MILPITAS PLANNING COMMISSION STAFF REPORT

November 24, 2014

APPLICATION: **INTEGRAL CENTRE POINTE MIXED USE — MT13-0007, SD13-0013, UP13-0013** – A request for a Site Development Permit, Major Tentative Map and Conditional Use Permit for the construction of 362 apartment units, approximately 55,431 square feet of commercial space in a mixed use building and approximately 241 condominium/townhouse units and associated site improvements on 15.68 acres (“Project”).

RECOMMENDATION: **Staff recommends that the Planning Commission: Adopt Resolution No. 14-038 recommending the City Council deny the Major Tentative Map, Site Development Permit and Conditional Use Permit for 362 apartment units, approximately 55,431 square feet of commercial space in a mixed use building and approximately 241 condominium/townhouse units and associated site improvements located in the McCandless/Centre Pointe and Montague Corridor Sub-Districts of the Transit Area Specific Plan (TASP).**

Figure 6
Proposed Centre Pointe Project – Neighborhoods A, B and C

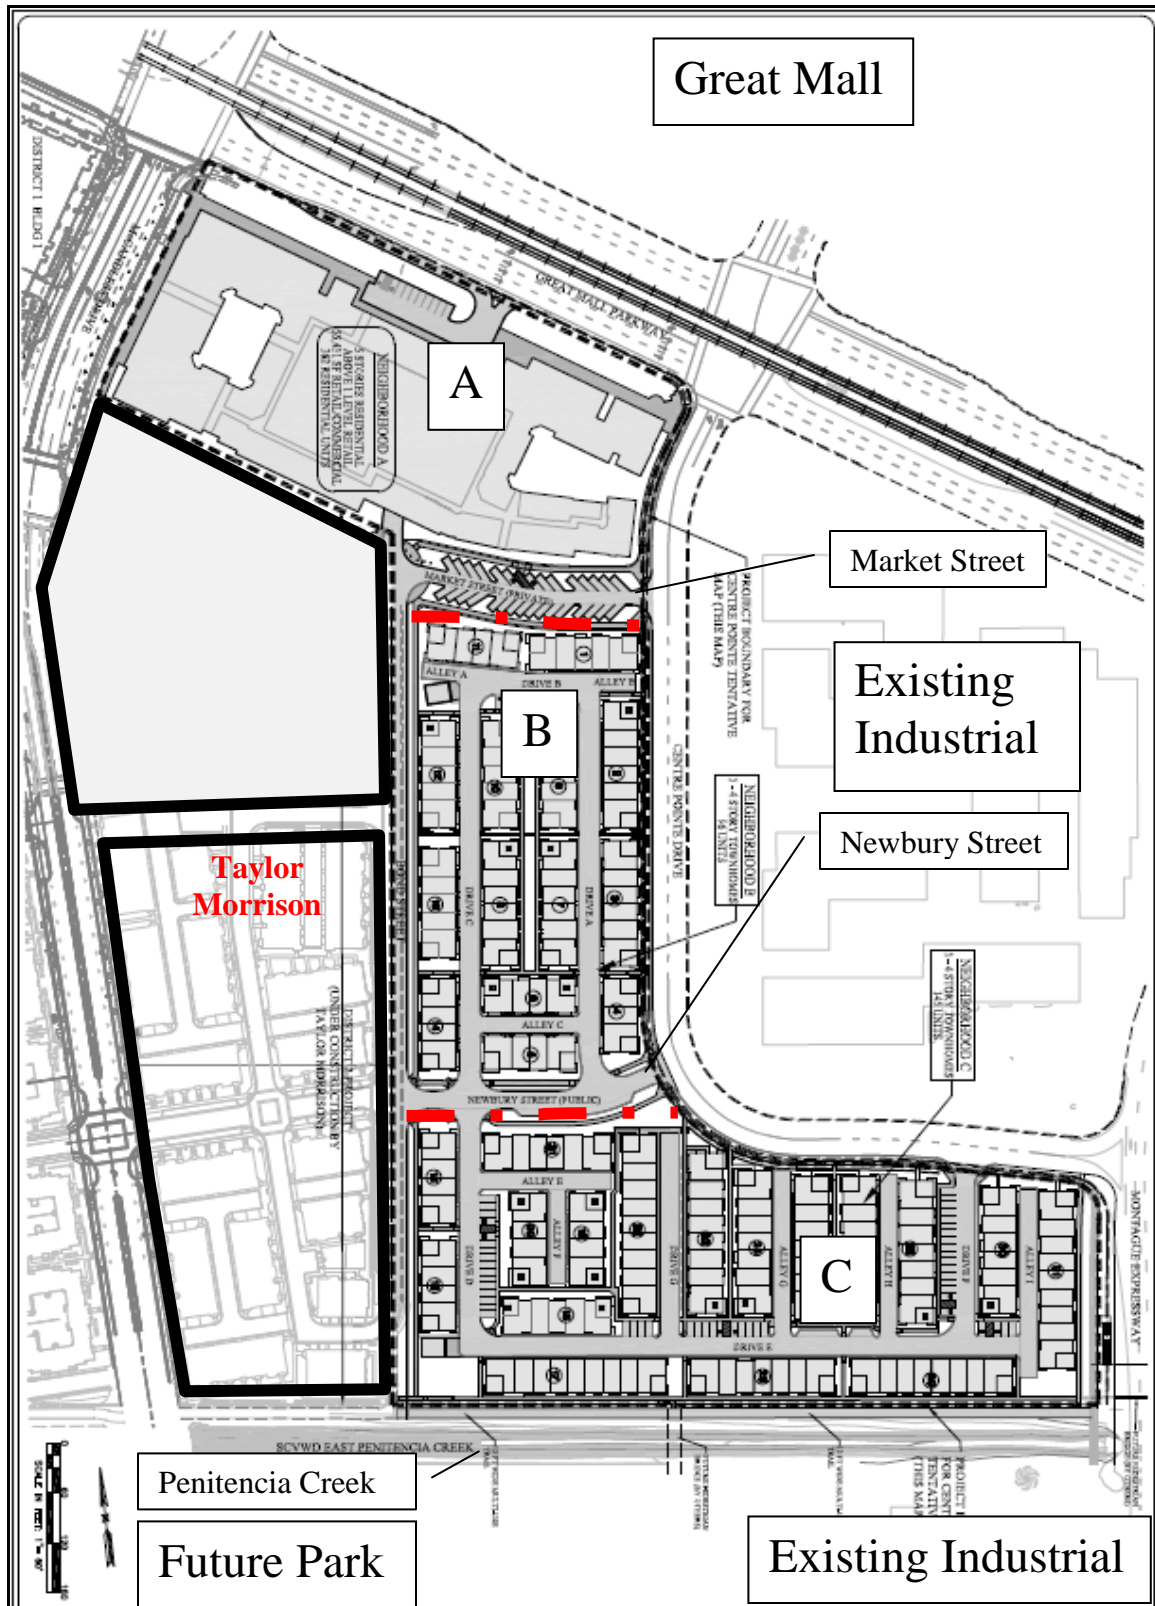
The street level condominium/townhome units in Neighborhood B are inconsistent with the “Residential – Retail High Density Mixed Use” Specific Plan land use classification and are not permitted in the MXD2 zoning district. The TASP “Residential – Retail High Density Mixed Use” land use classification is intended for ground floor retail and restaurant uses with residential, office, and/or hotel uses on the upper levels. Additionally, the MXD2 zoning designation prohibits multi-family housing as a primary use on the ground floor. The Project includes ground floor multi-family housing in Neighborhood B. As identified above, this is not permitted in the MXD2 zone and is inconsistent with the vision for the Residential – Retail High Density Mixed Use district in the TASP. An application for a specific plan amendment and zone change is necessary

Like Neighborhood B, mixed use Specific Plan classifications and zones are found in Neighborhood C. The Specific Plan and Zoning classifies a portion of the land uses in Neighborhood C as Boulevard Very High Density Mixed Use (BVHDMU) and the Very High Density Mixed Use Zone (MXD3), respectively. Unlike Neighborhood B, the BVHDMU and MXD3 zone does not prohibit ground floor residential uses. However, the classification and zone encourages high intensity office, commercial, and mixed use development.

It is important that properties in Neighborhood C incorporate commercial and professional office uses. The TASP anticipated and planned for the properties with the MXD3 Zone to be developed with commercial and retail uses. By not including these uses in Neighborhood C, the office and commercial square footage allocated in the TASP will be transferred to other parcels and create an imbalance and overly concentration of office and commercial use on certain parcels and none in others. This process creates single residential use areas, which is inconsistent with the TASP land use and Zoning vision. The TASP envisioned the Montague Corridor sub-district as an attractive, high density, urban neighborhood with a mix of land uses including rows of high profile buildings along Montague Expressway. Shifting the required retail uses to one large building along Great Mall Parkway further degrades the overall vision for the TASP.

Neighborhood C is located in the Montague Corridor sub-district of the Specific Plan. The sub-district encourages high rise buildings along Montague Expressway (Policy 4.1 (MON)). The proposed Project is inconsistent with this policy because it provides three- and four-story residential condominiums/townhomes along Montague Expressway as zoned for and envisioned in the TASP.

The residential density provided in the MXD3 Zone of the Project is **16 dwelling units per acre less than the minimum** amount required by the Specific Plan and Zoning. To address this, the TASP (Policy 3.8) allows for averaging the residential density over parcels in the development. The City has the discretion to consider residential density transfers when considering the overall TASP vision and various urban design policies and guidelines in while. The Policy never intended to allow a blanket shift of residential units from one zone to another in the mass and quantity requested by the applicant.

Properties Zoned MXD2 only exceed the maximum density by approximately 3.5 dwelling units per acre. The result of this project is similar to the “District I” project. The Centre Pointe Project proposes moving the residential density towards the northern end of the development, while diluting the southern portion. Ultimately, this approach is inconsistent with the TASP and Zoning objectives for “high density urban neighborhoods,” and leaves the TASP vision and Zoning requirements unfulfilled

Further, as referenced in Table 1, the residential density for the proposed Neighborhood A is 80.9 dwelling units per acre. The TASP allows a density bonus of 25 percent for with approval of a use permit. This would increase the maximum permitted residential density to 62.5 dwelling units per acre. Clearly, the 80.9 dwelling units per acre exceeds the maximum permitted even with the use permit. Therefore, Neighborhood A does not comply with the density ranges permitted by the TASP and Zoning.

The Project shifts all required commercial/retail land use to Neighborhood A. The Project provides 55,431 square feet of space labeled as commercial. However, this space includes a club house, leasing office and gym. Subtracting this area from the square footage provided yields a total square footage of 49,748 square feet. This is less than the required commercial square footage for the project.

Further, the Project places all commercial area in Neighborhood A in one single large building along Great Mall Parkway. As discussed previously, there is no commercial space dedicated in Neighborhood B, as required by the MXD2 Zone. This aspect of the project is inconsistent with the TASP vision of high density mixed use neighborhoods and it is not permitted by the Zoning Ordinance.

Additionally, the commercial spaces within the single large building does not meet the minimum depth requirements for ground floor commercial uses, as prescribed by Table 5-1 in the TASP. Specifically, Table 5-1 states that ground floor commercial spaces shall be 75 feet deep with a minimum depth of 60 feet. The plans illustrate that the commercial spaces are only 34 feet deep, which significantly reducing their potential for successful commercial/retail tenants. This presents another inconsistency with the TASP, and another reason that the Planning Commission should not recommend project approval.

TASP development standards prohibit parking that is visible from streets. Neighborhood A proposes parking along Great Mall Parkway. While the proposed Project indicate that landscaping might screen this parking area, additional information is required to determine if it is not visible from streets. Further, the goal of TASP is a pedestrian friendly, street oriented design. Placing parking at the front of a building along a street frontage is inconsistent with pedestrian and street oriented design objectives of the TASP.

The Project conforms to the overall setback of 45 from the top of the stream bank. However, the TASP requires that buildings be setback a minimum of 20 feet from the trail. The project proposes an 18.5 foot setback from the trail, which is inconsistent with the TASP.

Figure 7
TASP Street Network for Centre Pointe

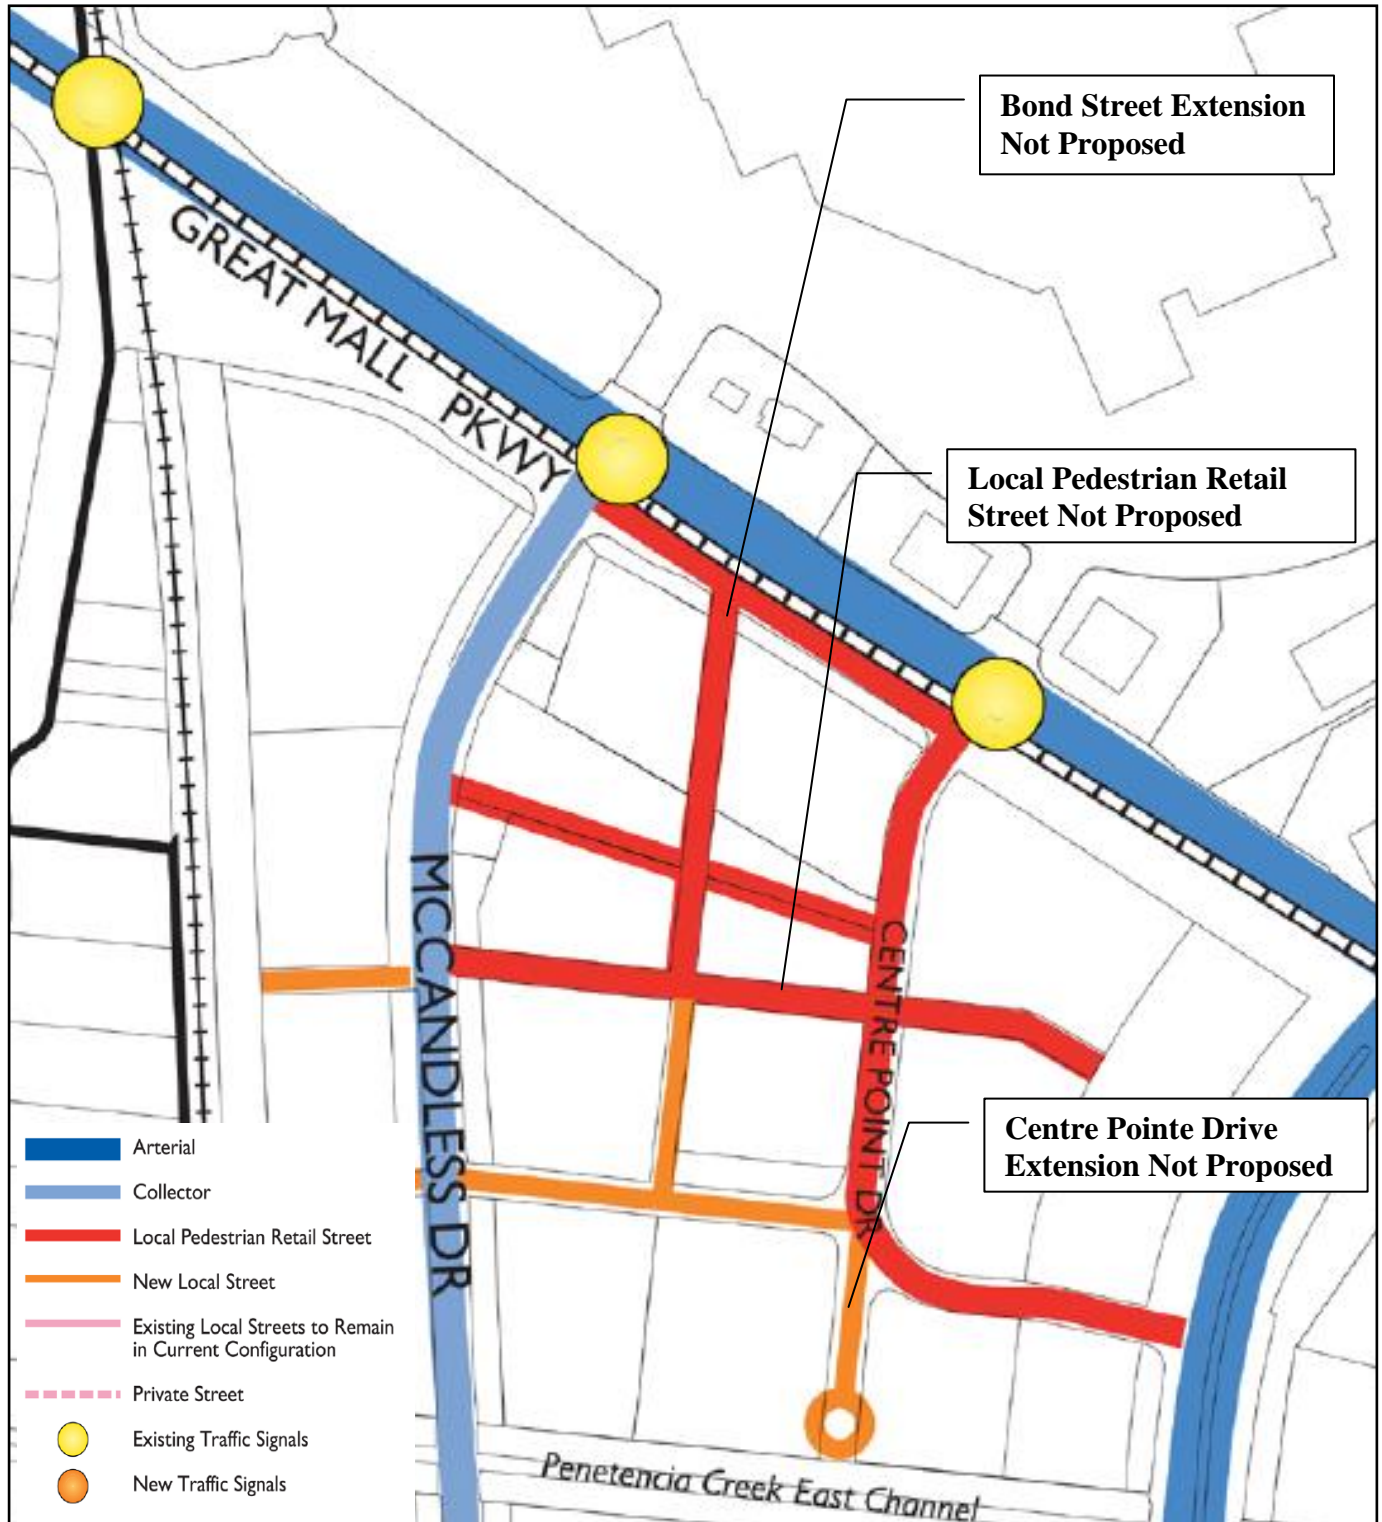
The proposed Project's circulation system is inconsistent with the TASP. Figure 7 illustrates the street network prescribed by the TASP. The inconsistencies with this network are summarized by street on the subsequent page.

The TASP illustrates Bond Street providing a connection to Great Mall Parkway. The proposed Project does not extend Bond Street to Great Mall Parkway and instead, Bond Street ends at a parking garage for Neighborhood A inconsistent with the TASP. TASP Policy 4.60 requires that block lengths do not exceed 450 feet, and encourages shorter block lengths of 300 to 400 feet. Bond Street measures approximately 610 feet from Newbury Street to Market Street. Therefore, Bond Street is inconsistent with the TASP street layout and block lengths.

The street layout and alignment for proposed Centre Pointe Drive does not extend southward as planned for in the TASP. Additional analysis and studies are needed to determine the ultimate alignment and layout for this roadway and may be inconsistent with the TASP. Further, Centre Pointe Drive measures approximately 560 feet from Newbury Street to Market Street. This is inconsistent with TASP Policy 4.60 which requires block lengths not to exceed 450 feet.

The TASP Street Design and Character Plan illustrates a street bisecting the approximate location of Neighborhood B. The proposed Project does not incorporate this street. The TASP identified street is designed to be used as a pedestrian retail street. This proposed missing street further emphasizes the projects inconsistency with the TASP and the importance of providing mixed use development along a planned street frontage in Neighborhood B.

There are improvements identified in the TASP to Montague Expressway that do not match the street cross sections provided on the proposed Project. These include the following:

- Provision of a 20 foot wide frontage road and 10 foot landscape median separating the frontage from the bike lane.
- Policy 4.5 requires that new developments dedicate 79 feet of land from the roadway centerline. This information is not provided on the plans.

The Project proposes 15 foot wide elevated sidewalk and 14 foot landscaped and easement area from the building to the right of way. This is inconsistent with the TASP cross sections. TASP prescribes buildings to be placed at the back of a 25 foot wide sidewalk. A six foot wide sidewalk and 20 foot wide planting strip are to separate the sidewalk from the right of way.

The proposed Project is not consistent with the TASP standards for Great Wall Mall Parkway. Moving from the center of Great Mall Parkway toward the building, the TASP identifies a street cross section containing a 13 foot median/turn lane, 17 foot wide turn lane; 12 foot wide travel lane; six foot wide bike lane, 14 foot travel lane, 24 foot planning strip, 10 foot sidewalk and a 10 foot setback. The proposed Project includes a 22.5 planting strip, 12 foot stormwater treatment area and a 15 foot sidewalk, which is inconsistent with the TASP.

McCandless/Centre Pointe sub-district Policy 4.60 states that the “block dimensions shall generally be between 300 and 400 feet, and shall never exceed 450 feet.” The block length for the proposed Project

along Bond Street is approximately 610 feet, and the block length from Newbury Street to Market Street is approximately 560 feet. Both of these block lengths are inconsistent with Policy 4.60.
